UNITED STATES PATENT AND TRADEMARK OFFICE

| APPLICATION NO. | FILING DATE | FIRST NAMED INVENTOR | ATTORNEY DOCKET NO. | CONFIRMATION NO. |
|--|-------------|----------------------|------------------------------|------------------|
| 10/578,854 | 05/11/2006 | Herbert Brunner | 12406-187US1 P2003.0931 U | 3209 |

Office Action Summary

DETAILED ACTION

FIG. 2

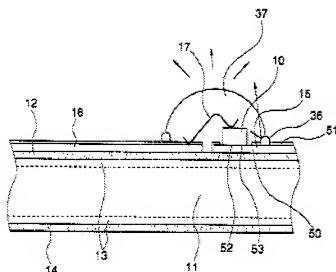
9. **With respect to claim 1**, Sakamoto (e.g. Figure 2) teaches a radiation-emitting and/or radiation-receiving semiconductor component comprising:

- A radiation-emitting and/or radiation-receiving semiconductor chip 10;
- A molded plastic body 37, ***made of a silicone molding compound*** (column 7, lines 48-51), which is at least partially transmissive to an electromagnetic radiation to be emitted and/or received by the semiconductor component (column 7, lines 44-49) and by which the semiconductor chip 10 is at least partially overmolded; and

- External electrical leads (15, 16) that are electrically connected to electrical contact areas of the semiconductor chip (column 5, lines 56-67),
- Wherein the semiconductor chip is mounted on a flexible lead frame (column 6, lines 47-50)

Sakamoto fails to teach that the flexible lead frame comprises *a carrier film that comprises at least a plastic film and a metal film, and wherein the plastic film has an opening and the semiconductor chip is positioned in the opening and directly contacts the metal film.*

With respect to claim 39, Sakamoto (e.g. Figure 2) teaches that the molded plastic body is formed of a single piece of plastic.

With respect to claim 40, Sakamoto (e.g. Figure 2) teaches a radiation-emitting and/or radiation-receiving semiconductor component comprising:
